# Styrax Fashions Ltd. (10244)

Plot # 194 DEPZ (Ext.), Ganakbari, Savar, Dhaka

09.MARCH.2014

**ACCORD**  
on Fire and Building Safety in Bangladesh

Lack of vertical bracing

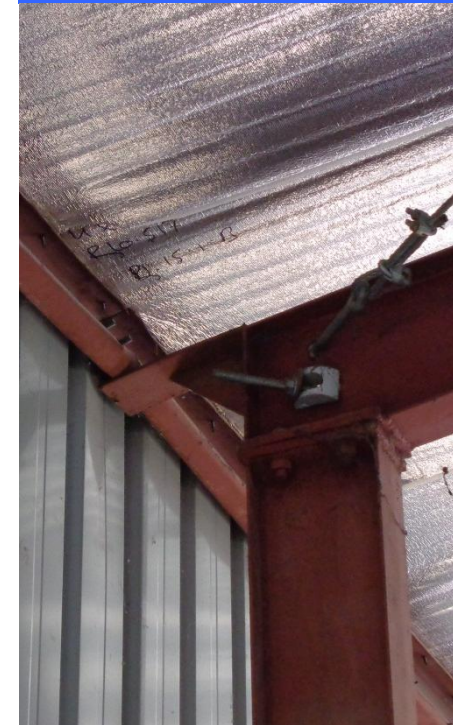
There was present at the roof level a steel framed structure. Connections were observed to be poorly constructed. The structure had no lateral load restraint system.

Priority 2 Concern

- A detailed engineering assessment is to be performed upon the steel roof structure.

- Carry out any remedial measures or alteration works deemed necessary by the aforementioned structural assessment.

Nuts left loose on anchor bolts

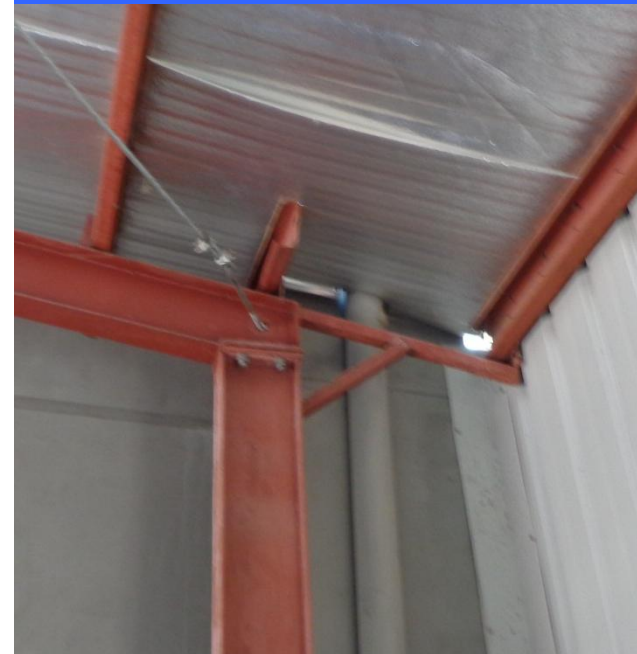
Poor connection detailing at steel roof structure

Priority 2 Concern

**ITEM 1: (Priority 2) At the steel roof structure connections were inconsistent and suspect in their capacity. Also, untightened anchor bolts were observed.**

Poorly detailed steel framing

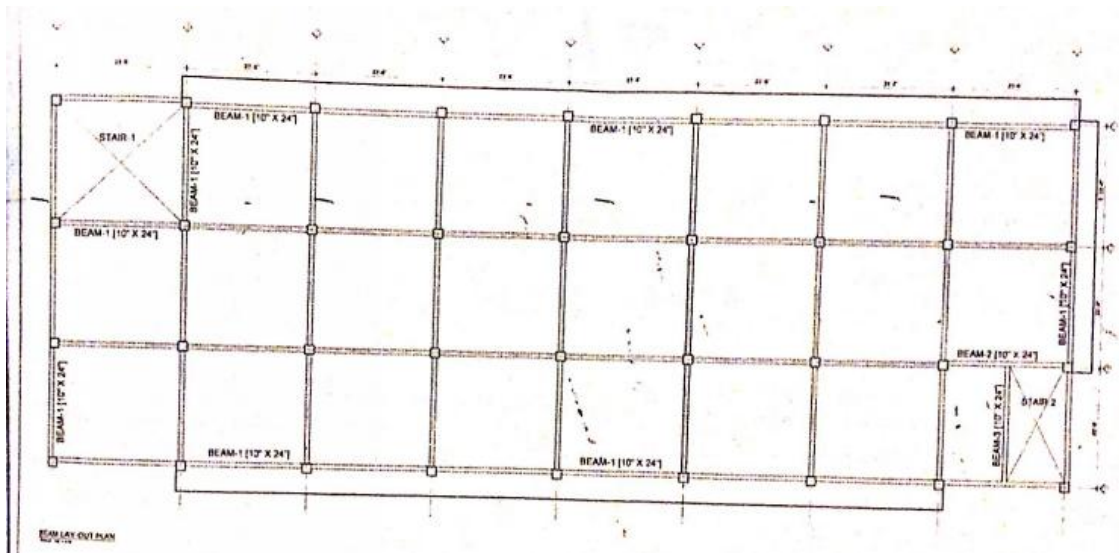
Priority 2 Concern

The steel roof structure displays signs of overloading and connections are detailed in a poor fashion.

Discrepancies between structural drawings and actual construction

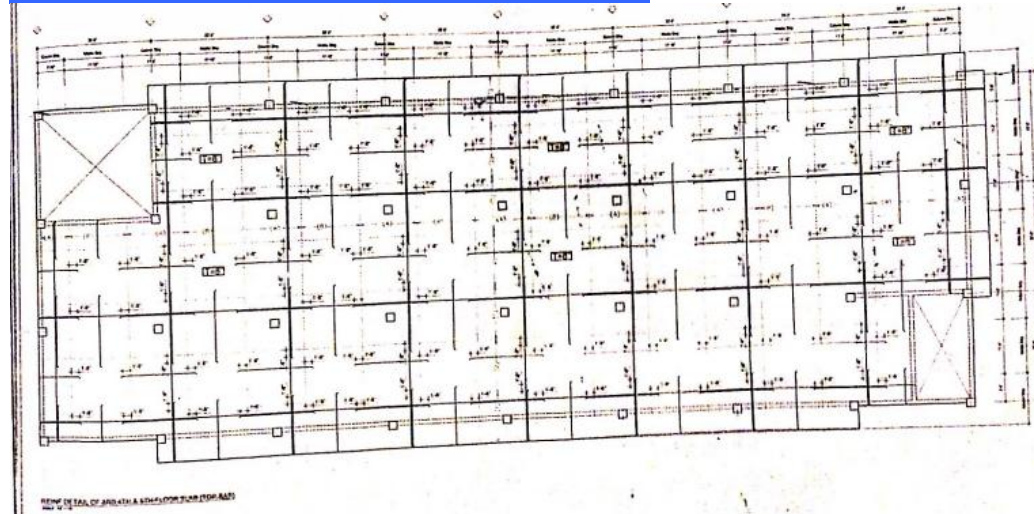
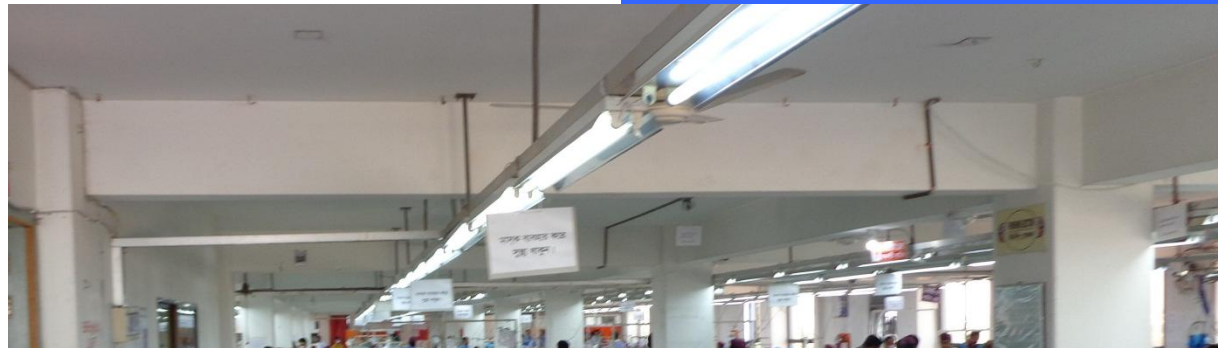
It was noted that the 1<sup>st</sup> & 2<sup>nd</sup> floor slabs were a flat slab arrangement and the 3<sup>rd</sup> to Roof slabs were a beam/slab arrangement. Structural Drawings show a beam/slab arrangement for typical floors and a flat slab arrangement at the 3<sup>rd</sup>, 4<sup>th</sup> & 5<sup>th</sup> floors.

In addition to this discrepancy, the structural drawings do not show the steel frame upon roof level.

**Discrepancies between structural drawings and actual construction**

Drawings are inconsistent with actual construction.

- A detailed engineering assessment is to be conducted on the building in order to determine the capacity of the structure in its existing condition.

- Update the structural drawings to reflect the as-built conditions, and carry out any remedial measures deemed necessary by the aforementioned engineering assessment.
